**ZONING AMENDMENT,
PLANNED UNIT DEVELOPMENT &
SUBDIVISION STAFF REPORT**

Date: March 5, 2009

<u>NAME</u>	Kentress Morrisette
<u>SUBDIVISION NAME</u>	Booker T. Washington Highlands Subdivision, First Addition, Block F, Resubdivision of Lots 8 & 9
<u>LOCATION</u>	Southeast corner of First Avenue and Prince Street
<u>CITY COUNCIL DISTRICT</u>	District 1
<u>PRESENT ZONING</u>	R-1, Single-Family Residential
<u>PROPOSED ZONING</u>	R-3, Multiple-Family Residential
<u>REASON FOR REZONING</u>	Changing conditions in the area
<u>AREA OF PROPERTY</u>	1 Lot / 0.3± Acre
<u>CONTEMPLATED USE</u>	<p>Subdivision approval to create 1 legal lot of record, Planned Unit Development Approval to allow two apartment buildings on a single building site, and Rezoning from R-1, Single-Family Residential, to R-3, Multiple-Family Residential, to allow an eight-unit apartment complex.</p> <p>It should be noted, however, that any use permitted in the proposed district would be allowed at this location if the zoning is changed. Furthermore, the Planning Commission may consider zoning classifications other than that sought by the applicant for this property.</p>

SITE PLAN

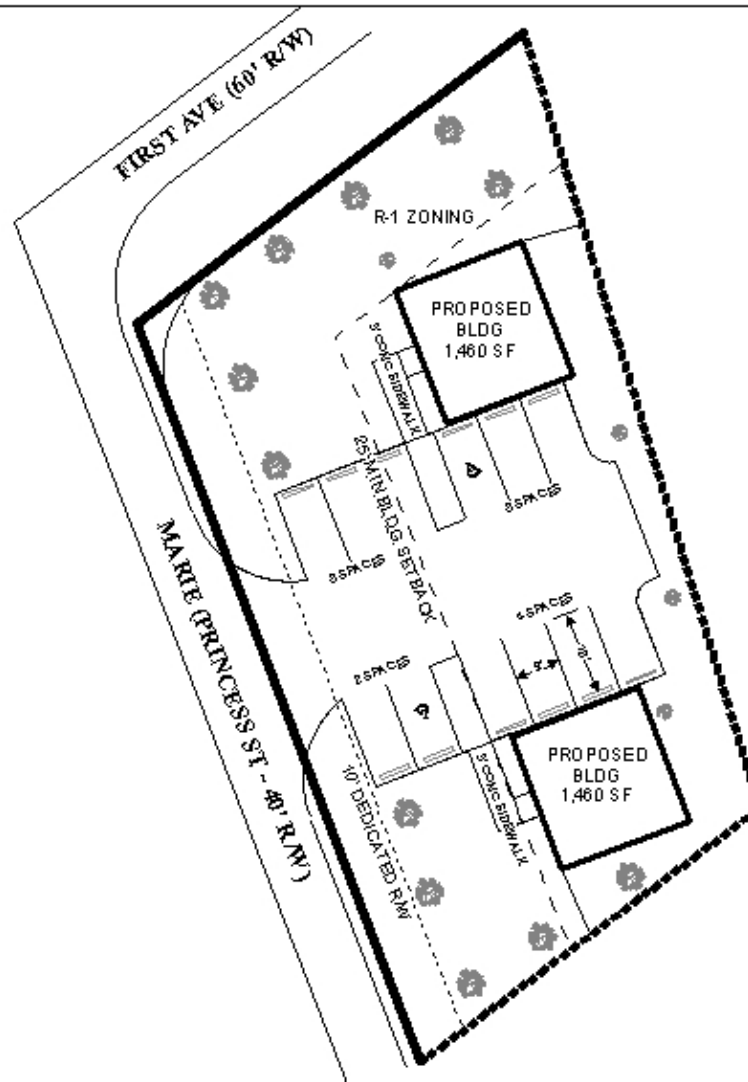
The applicant proposes an eight-unit apartment complex consisting of two buildings. The site is proposed to hold 12 parking spaces, the minimum amount required as per the Zoning Ordinance. The applicant proposes to access the parking area from Prince Street, which does not appear to meet City of Mobile standards. Considering the traffic generated by an eight-unit apartment complex, no development of this PUD should be allowed until such time that Prince Street is brought up to City of Mobile standards.

The southernmost building is located within the required side yard. A side yard setback of at least eight feet is required in an R-3 zoning district. Additionally, for an eight-unit apartment complex, a minimum lot area of 17,000 square feet is required (8,000 for the first two units plus 1,500 square feet for each additional unit). The site only contains 12,945 square feet, which does

meet requirements. In fact, a 12,945 square foot site would only contain enough area to allow a five-unit apartment complex.

No buffers are shown between this site and the neighboring single-family residential areas. A buffer in compliance with 64-4.D.1 of the zoning ordinance would be required where the site abuts a single-family residential district.

There is a note on the site plan regarding trash pickup, which will be accomplished via curbside pickup, thus eliminating a dumpster requirement. However, should there come a time when a dumpster needs to be placed on site, an Administrative PUD will be required and the dumpster would need to comply with Section 64-4.D.9 of the Zoning Ordinance.

The landscaping and tree plantings, as depicted, meet the minimum standards of the Zoning Ordinance. Compliance with landscaping and tree planting requirements would be required.

- 1) The site does not meet the minimum lot size requirements for the proposed eight apartment units; and
- 2) The southernmost structure in the development does not meet minimum setback requirements.
